CORPORATION OF THE TOWNSHIP OF ESQUIMALT

Staff Report

Report No. APC-21-011

Official Community Plan Amendment and Rezoning Application - 819 Esquimalt Road (including 821 and 823 Esquimalt Road)

re-issue no: **2** sheet no: **A0.7**

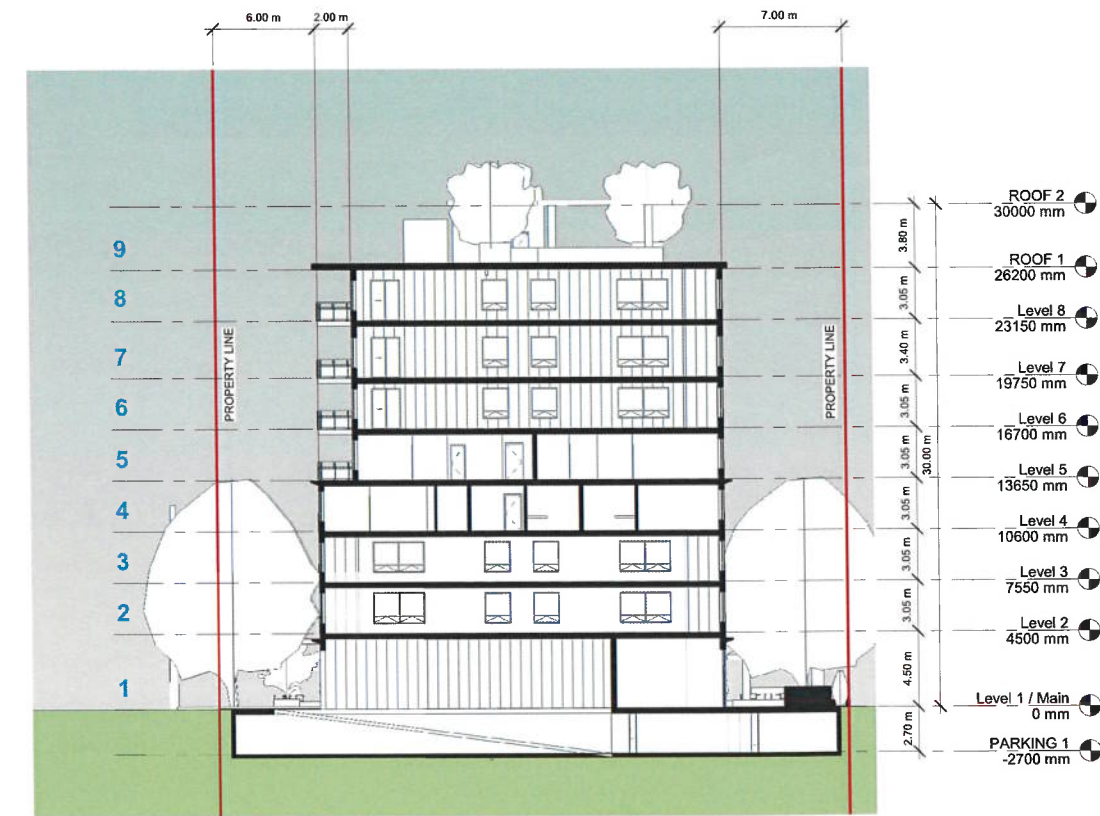
Staff note that the height of the building is unexpectedly high due to the design choice of including a covered pergola on the roof which must be accommodated in the height calculation (Appendix A, sheet A0.7). This results in a calculated height of 30.0 m, functionally a 9 storey building.
